Dewberry Springs Subdivision

City Plan Commission — July 2, 2026 **REVISED**

CASE NUMBER/TYPE: SUSU26-00034 – Major Combination
CASE MANAGER: Myrna Aguilar, (915) 212-1584, AguilarMP@elpasotexas.gov
PROPERTY OWNER: DVEP Land, LLC
REPRESENTATIVE: Del Rio Engineering, Inc.
LOCATION: East of Resler Dr. and North of Transmountain Rd. (District 1)
PROPERTY AREA: 6.84 acres
VESTED RIGHTS STATUS: Not Vested
PARK FEES: \$60,280.00
EXCEPTIONS/MODIFICATIONS: Yes, see following section
ZONING DISTRICT(S): P-R II (Planned Residential District II)
RELATED APPLICATIONS: PZR25-00010 – Dewberry Drive

ATTACHMENT 2

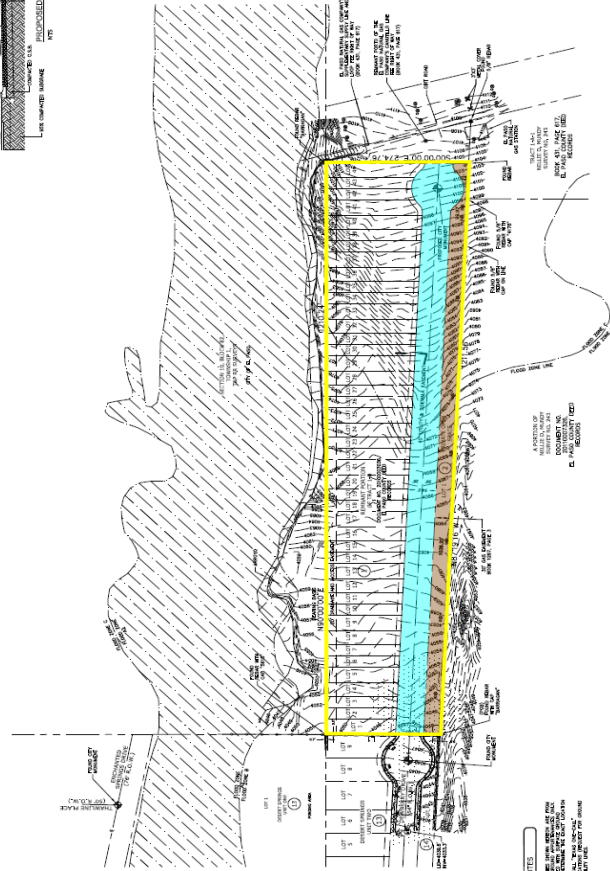
3. Place note on both preliminary and final plats specifying who will maintain the private open space.
4. Provide solid dark delineation line separating the private open space area from right-of-way area.

1. Update dedication statement incorporating all infrastructure if applicable Park and street.
2. Label street 54' R.O.W. with Dewberry Street name.
3. Provide cross section arrows indicating where cross section was taken along the street.
4. Provide typical lot drainage arrows. Update drainage note #7 specifying which subdivision pond will ultimately receive stormwater runoff. Remove note #6 is redundant.
5. On typical roadway cross section will be 4" rolled curb abutting residential lots, but along linear park with 6" standard curb on preliminary plat.
5. The subdivision shall be tied by bearing and distance to existing City monument along Dewberry Drive and delineate on the final plat.
6. Provide print-out of the mathematical closure of the exterior boundary of the subdivision indicating the error of closure.

1. Provide an acceptable Stormwater Management plan in accordance with Section 19.19.030 of the current subdivision ordinance.
2. Show and Label drainage flow patterns on the preliminary plat and identify the final location of all the stormwater runoff.
3. At the improvement plan stage, provide protection to the subdivision from all offsite storm water runoff that may have an adverse impact on any improvements and convey the existing watercourse through the subdivision.
4. The watershed for the Dewberry subdivision extends down to the Desert Springs subdivision and was not part of the design consideration for the Desert Springs Pond. The subdivision will need to retain the runoff for its post-developed conditions.
